CITY OF WESTMINSTER			
PLANNING APPLICATIONS SUB COMMITTEE	Date 28 June 2022	Classification For General Release	
Report of Director of Place Shaping and Town Planning		Ward(s) involved Lancaster Gate	
Subject of Report	19 Upbrook Mews, London, W2 3HG		
Proposal	Excavation of single storey basement beneath footprint of original dwelling, conversion of garage into habitable space and erection of a mansard roof extension with raising the height of the party wall with 18 Upbrook Mews.		
Agent	Mr architect nuspace		
On behalf of	Mr Sammy Li		
Registered Number	21/00155/FULL	Date amended/ completed	11 January 2021
Date Application Received	11 January 2021		
Historic Building Grade	Unlisted		
Conservation Area	Bayswater		
Neighbourhood Plan	Not applicable

Proposal: Excavation of single storey basement beneath footprint of original dwelling, conversion of garage into habitable space and erection of a mansard roof extension with raising the height of the party wall with 18 Upbrook Mews.

Reference: 21/00155/FULL

Proposed Front Elevation

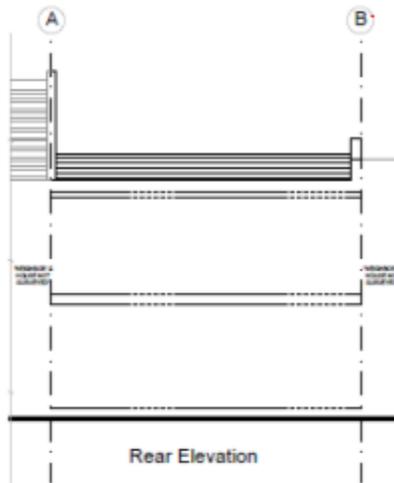
Objection raised on the grounds that the drawings show the proposed mansard roof higher than the adjacent houses; the windows on the front elevation of the roof are too large; the mansard roof may result in loss of light to neighbouring properties; flooding, loss of garage and that the basement appears to have no ventilation.

The mansard roof, as amended is a flat topped hipped mansard roof. Three traditional dormer windows are proposed to the front elevation and two windows are proposed in the rear roof slope. Objections to the volume created by the roof alterations and the impact that this has on the character of the mews and on the detailed design of the mansard have been received. The mansard has been designed to match the height and pitch of the neighbouring mansard at No. 18 Upbrook Mews as the front parapet wall to these two properties is set lower than the rest of the eastern side of the mews.

- 5 All new windows to the mansard roof and the new 'garage door' shall be constructed in timber and painted to match the existing and be retained in that condition thereafter.

Proposed Mansard & Roof Level Plan

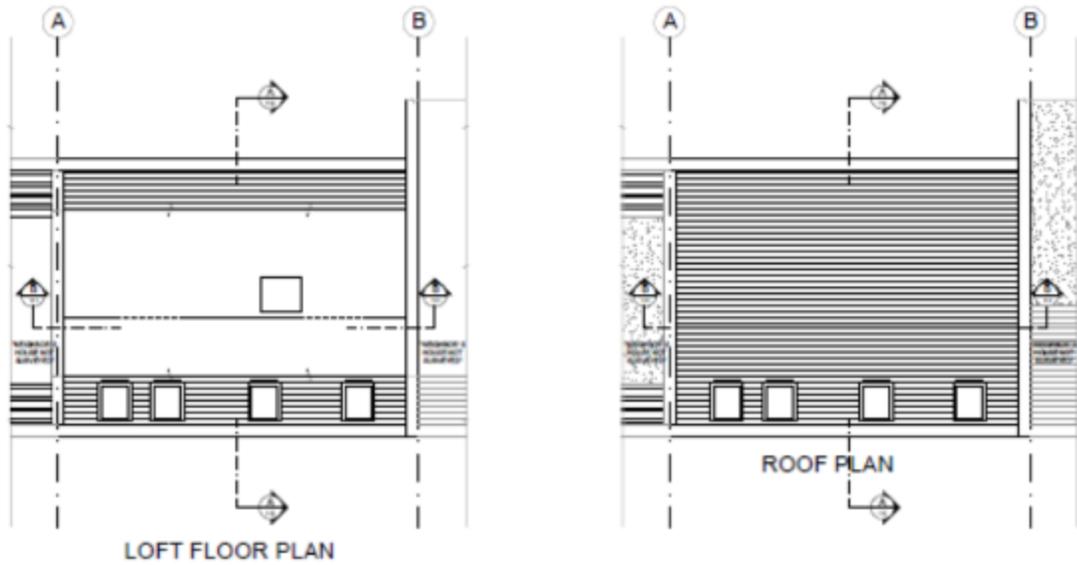
The original proposals sought permission for a mansard which had a slight second pitch and a large gable end abutting the rear boundary wall of 21-23 Chilworth Street. This has been amended during the course of the application to a flat roofed hipped mansard extension.

mansard roof is now hipped, so as not to raise the party wall with 21-23 Chilworth Street (and to improve the amenity to neighbours addressed below). Whilst No. 20 Upbrook Mews (opposite) has a tall gable ended mansard with the listed neighbours on Chilworth Street, it is not considered that a hipped mansard roof would look out of place within long views in the mews.

Proposed Section A-A

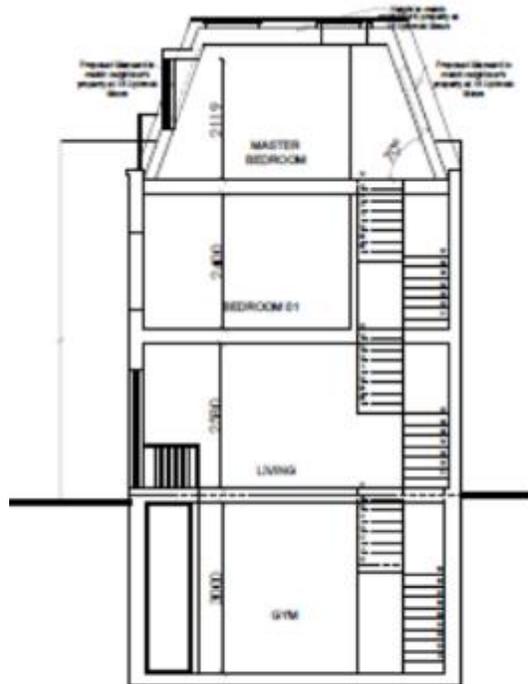
The windows to the rear of the mansard are sloped rooflights. Given their height and proximity to neighbouring windows within Chilworth Street it is recommended that these are non-openable and obscure glazed so as to prevent any harmful overlooking.

- 8 The glass that you put in the windows in the rear elevation of the mansard roof must not be clear glass, and you must fix it permanently shut. You must apply to us for approval of a sample of the glass (at least 300mm square). You must not start work on the relevant part of the development until we have given our written approval for the sample. You must then install the type of glass we have approved and must not change it without our permission. (C21DB)
